Addendum No. 3

Reference: South Garrison Infrastructure Phase II Camp Williams
Utah National Guard
DFCM Project No. 13240480

This addendum is being issued to provide clarifications to the Bid Documents (Drawings and Project Manual) dated June 23, 2014, and to respond to bidder questions.

EP101-BB

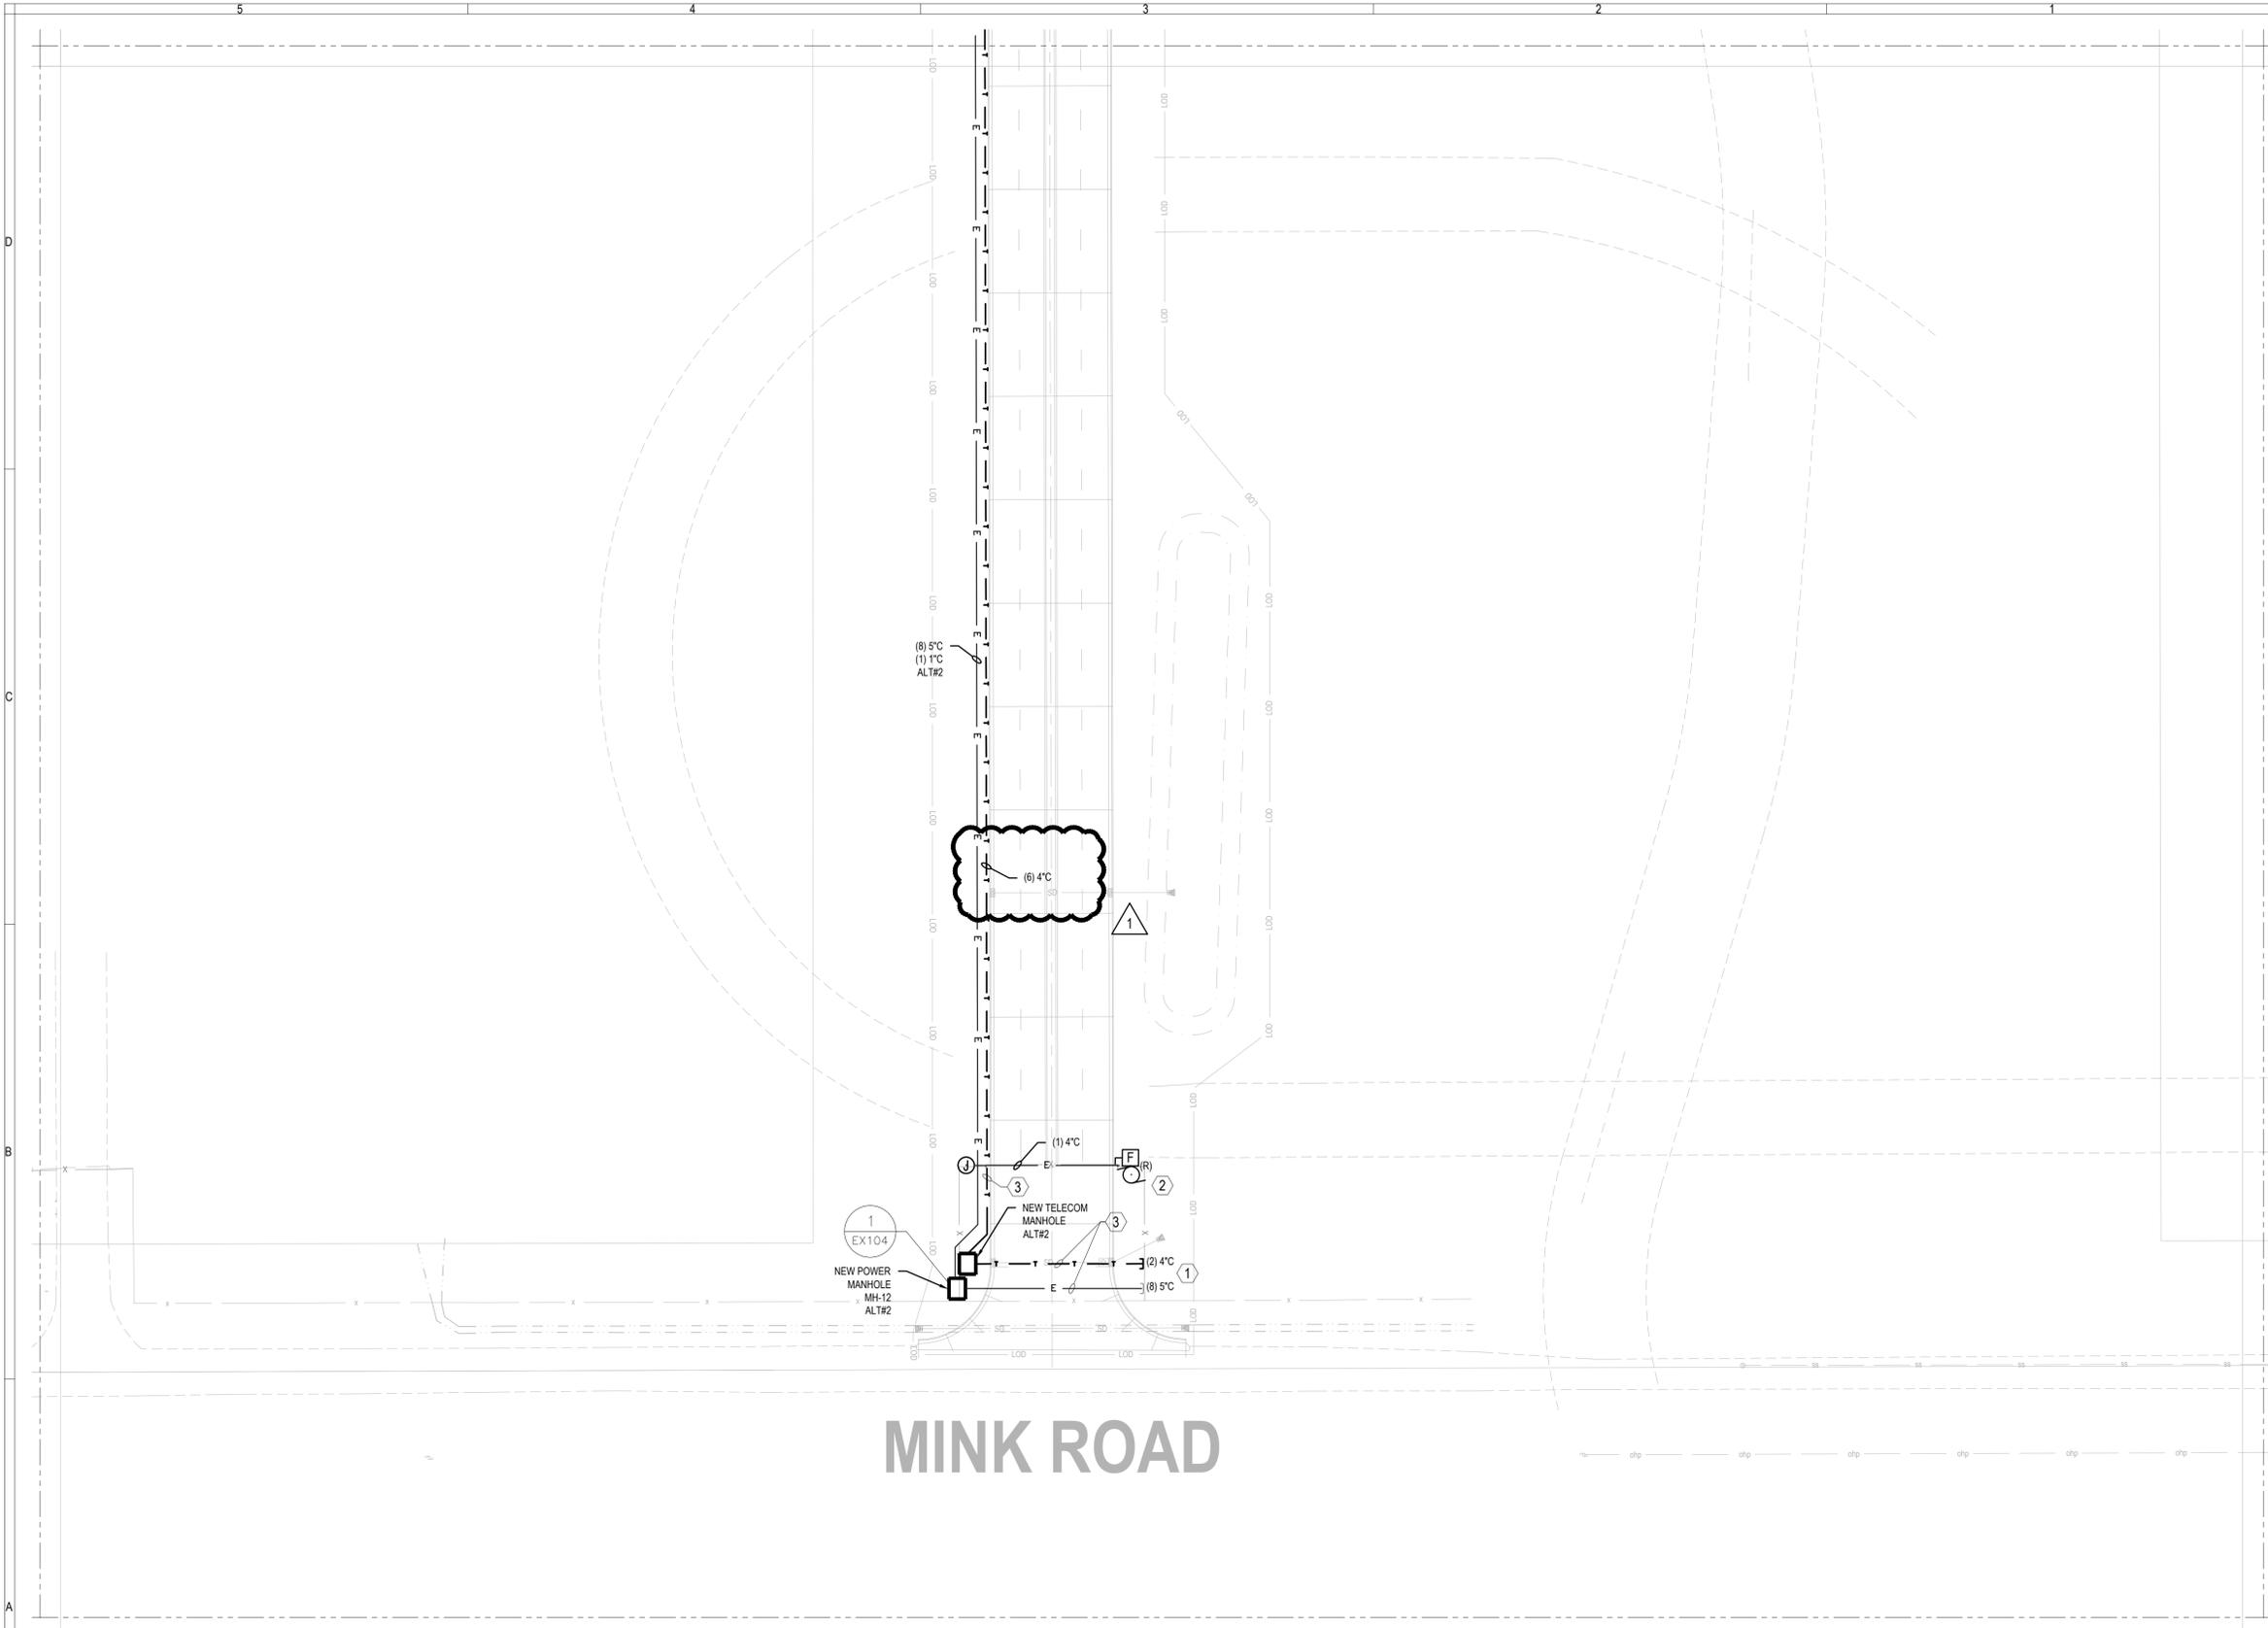
1. Identified telecom conduits as "(6) 4"C".
2. Modified Keyed Note 4 to say "Run conduits and provide pull rope as part of Alternate #2. Conductors to be provided in future."
3. Renumbered Keyed Notes.

- ① FURNISH AND INSTALL DEAD END POWER POLE WITH GUY WIRES AT LOCATION SHOWN AS ALTERNATE #2. EXTEND (1) 5" UP POLE TO 20' AFG. SEE SHEET EX105 FOR DETAILS. PROVIDE STANDARD POWER POLE IN BASE BID.
- ② RELOCATE EXISTING SG405 TO NEW LOCATION SHOWN TO FEED EXISTING OVERHEAD POWER. SEE DETAILS ON SHEET EX106 FOR SWITCH VAULTS.
- ③ REMOVE FROM BASE BID IF ALTERNATE #2 IS ACCEPTED.
- ④ RUN CONDUITS AND PROVIDE PULL ROPE. CONDUCTORS TO BE PROVIDED IN ALTERNATE #2

EP601

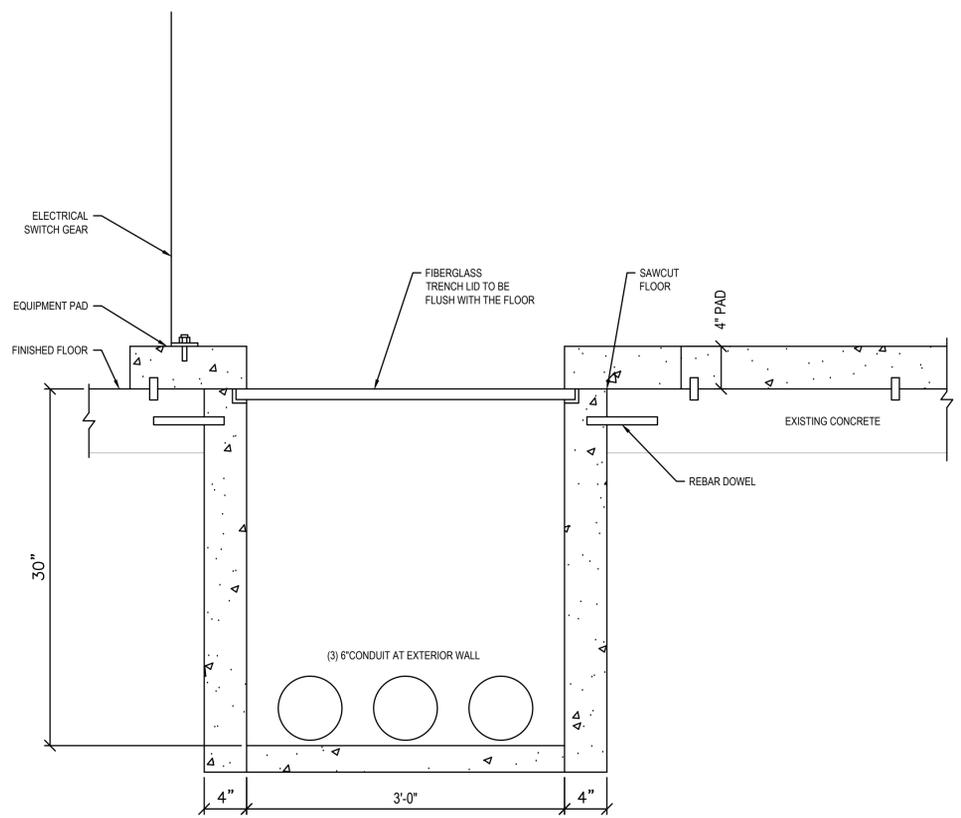
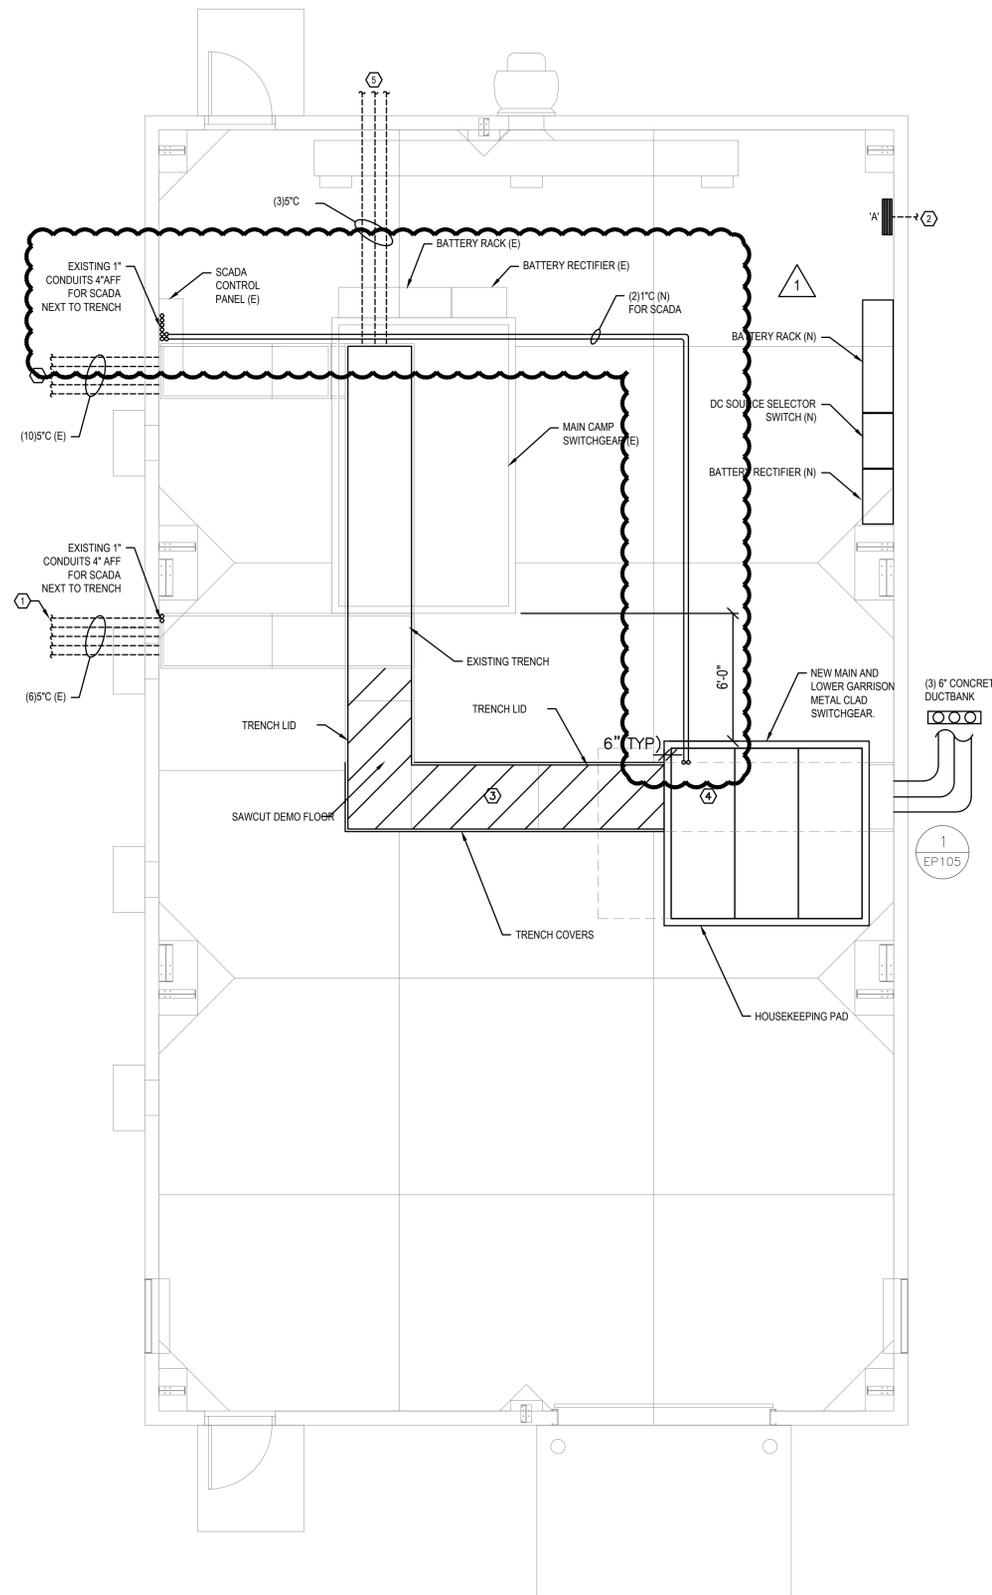
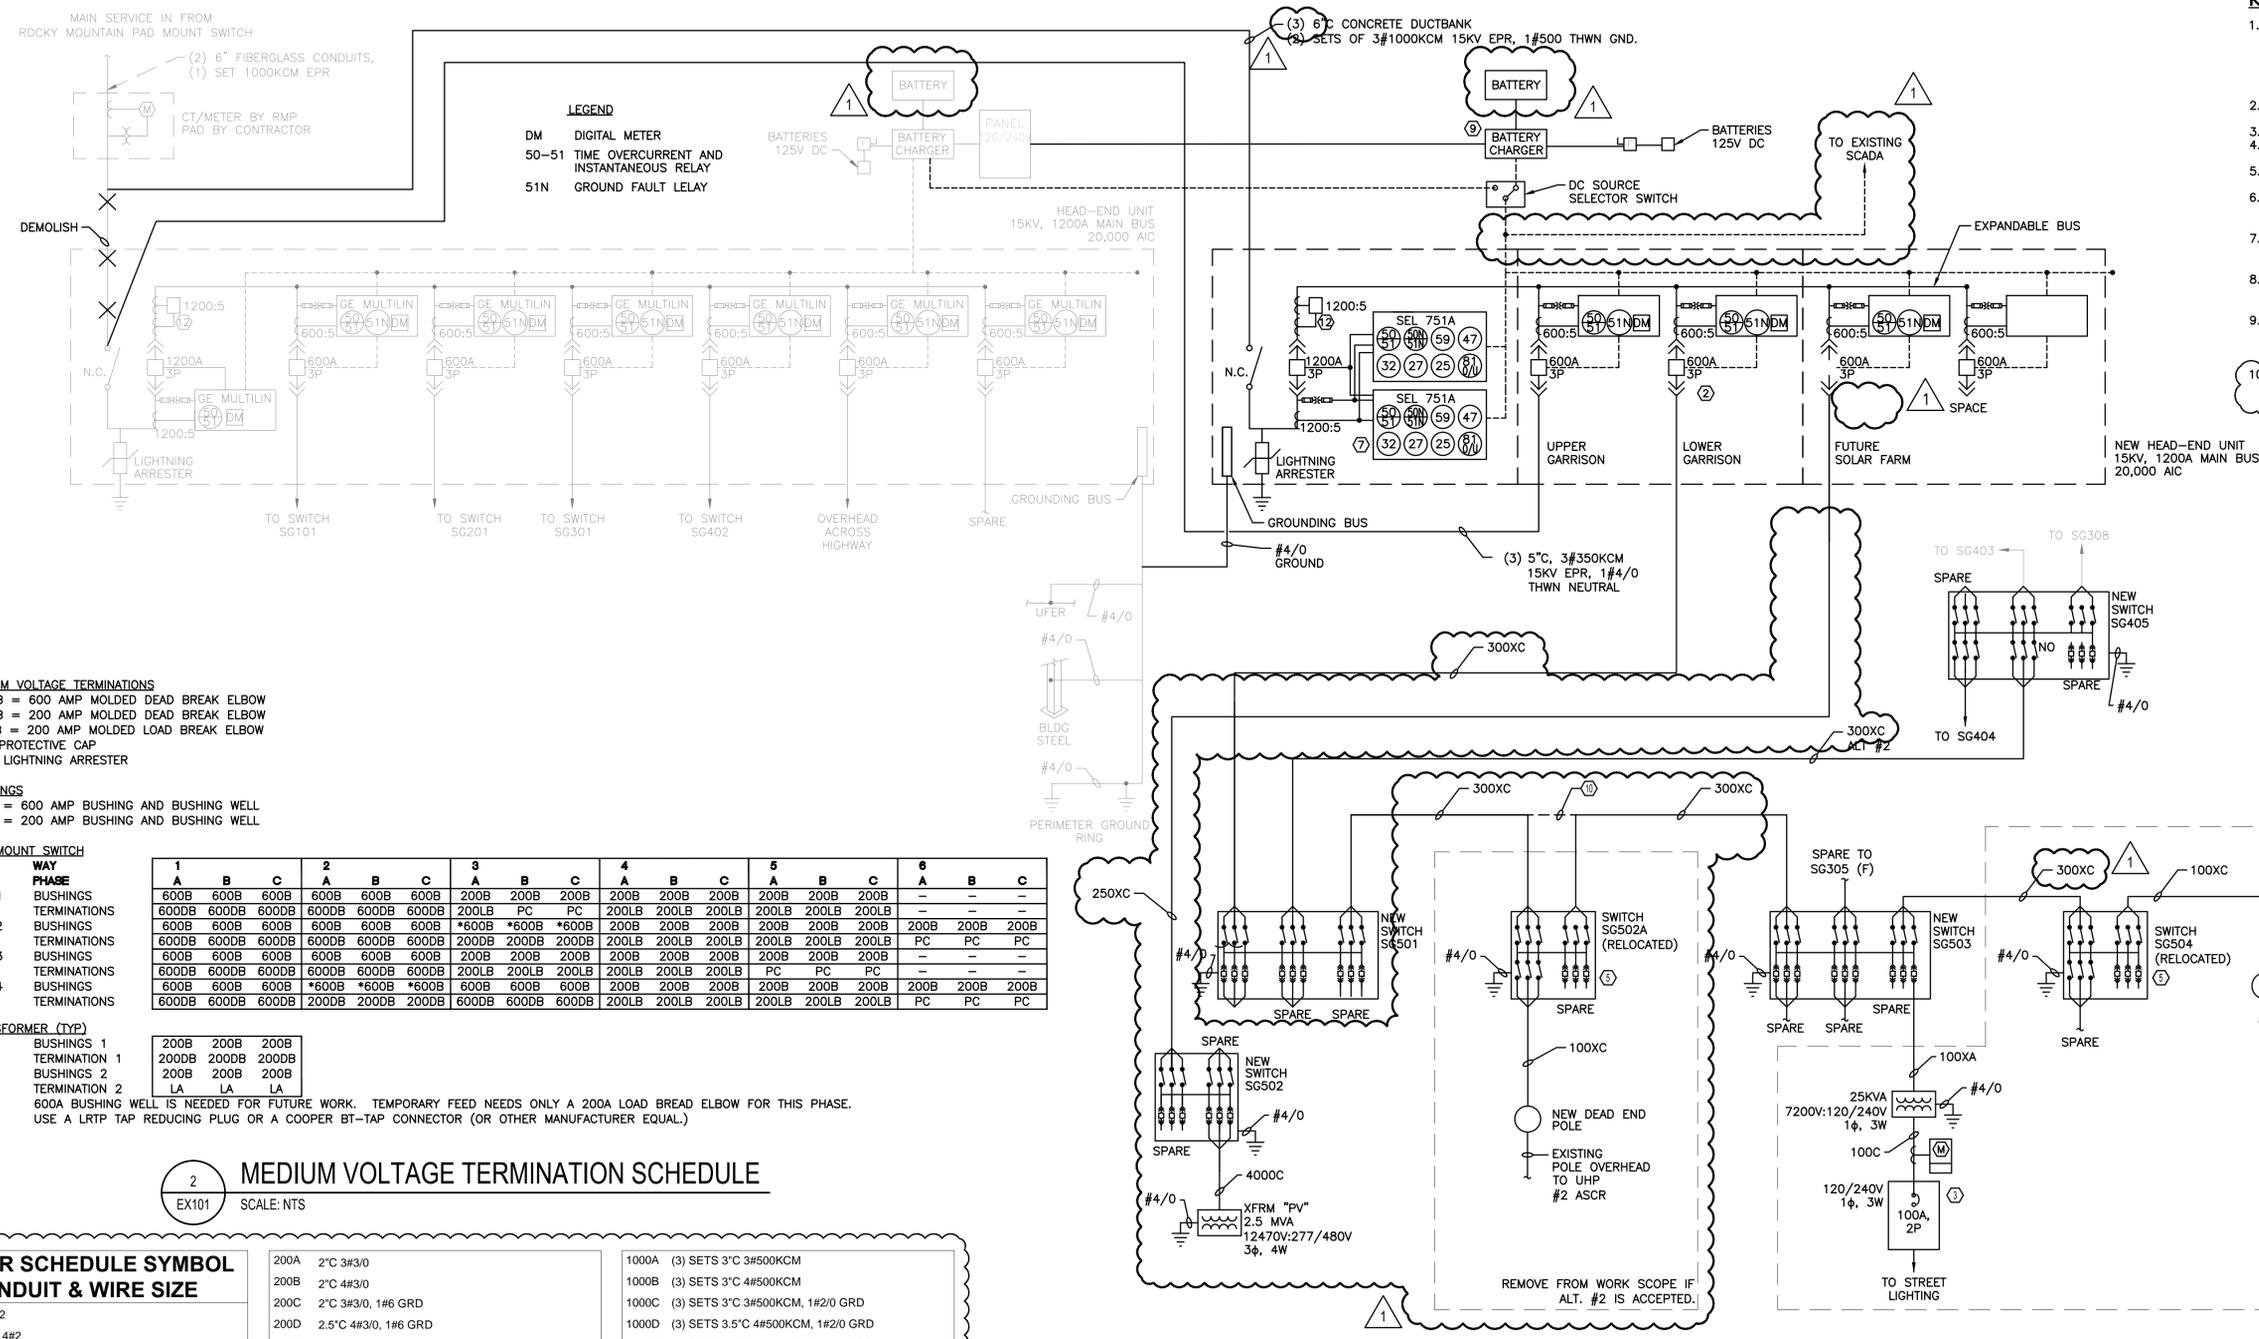
1. Added (2) 1”C for SCADA.

NEW ONE-LINE DIAGRAM PHASE 2
 SHEET NUMBER
EX101

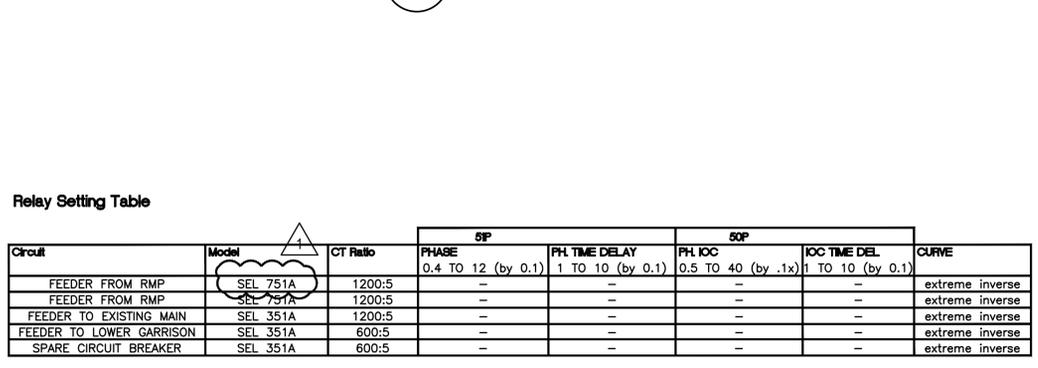
1. Changed “300XL” feeder callouts on One Line to “300XC”
2. Changed model from “SEL 351A” to “SEL 751A” on the Relay Setting Table.
3. Changed the quantity of conduits for 6”C Concrete Ductbank feeding the New Head-End Unit from “2” to “3”.
4. Clarified scope of work for SG502 if Alternate #2 is accepted.
5. Added Keyed Note #10.
6. Changed spare 600 Amp breaker in New Head End Unit to be Base Bid.
7. Added feeders, Switch, and transformer on One-Line for Future Solar Farm.
8. Updated Feeder Schedule

The feeder conduit/wire reference refers to 300XL. On the feeder schedule symbol conduit and wire size chart. There is no reference for the 300XL. Can you please clarify the 300XL conduit, wire, quantity and size?

Refer to Sheet EX101 under Drawings on DFCM website. 300XC on the Feeder Schedule should read 300XL.

6 MANHOLE DETAIL MH - 2,3,4,5
 EX104 SCALE: NTS

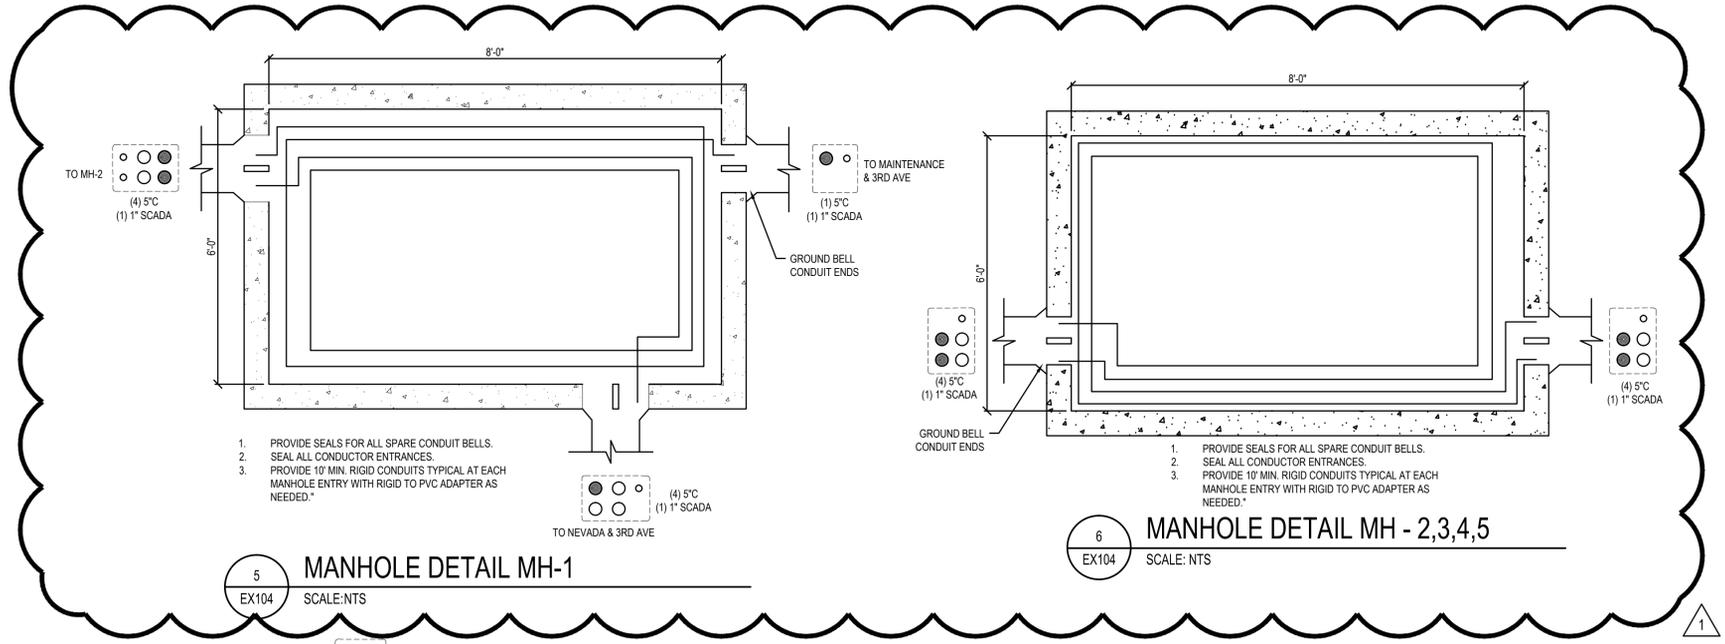
1. Add Note 3 on all Manhole details stating:
“Provide 10’ minimum rigid conduits typical at each manhole entry with rigid to PVC adapter as needed.”
2. Modified Details 5 and 6 to reflect addition of Solar Farm conductors.
